DOCKETED	
Docket Number:	24-SB-605
Project Title:	SB 605 Wave and Tidal Energy - Phase 2
TN #:	263175
Document Title:	Marcus Lehmann Comments - References to CalWave x1 open ocean pilot, San Diego CA 2021-22
Description:	N/A
Filer:	System
Organization:	Marcus Lehmann
Submitter Role:	Public
Submission Date:	5/16/2025 1:45:10 PM
Docketed Date:	5/16/2025

References to CalWave x1 open ocean pilot, San Diego CA 2021-22

Subject: Comments on the SB 605 Draft Consultant Report on Sea Space Analysis

Fig. 1: Co-location of offshore wind and wave farms sharing balance of plant but in independent permit and area.

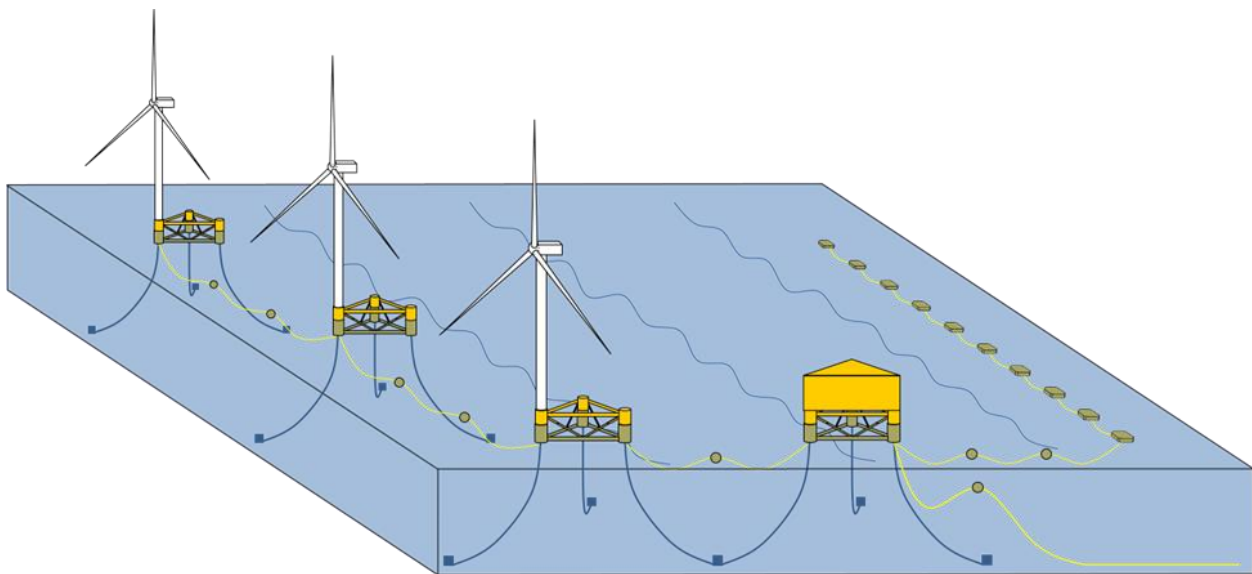
Page 45: We have two separate comments with regard to “Colocation With Offshore Wind Infrastructure.”

- 1) The report states that “The land-based and nearshore components of marine energy and wind energy operations could be colocated, potentially reducing the overall spatial and visual impact of that supporting infrastructure.”

These are relevant benefits of colocation, but the more critical and relevant opportunities are the shared utilization of balance-of-plant including on and offshore substations. This has the opportunity to:

2) The report states that “all wind energy lease areas are in medium-high wave energy areas, meaning there is resource potential for colocation of electrical cable connections or integration of WECs either into the turbine platform infrastructure itself or in the area within the turbine arrays.” We would like to highlight the point that all five BOEM offshore wind leases (two in Northern California off the coast of Eureka and three in South-Central California off the coast of Morro Bay) have significant wave energy resources. However, it is important to recognize the difficulty of integrating into the floating wind platforms themselves, especially given that floating offshore wind platform OEMs are still early in their growth phases as well. The most likely scenario may instead be that some offshore infrastructure is shared, like substations, export cables, and potentially even anchors.
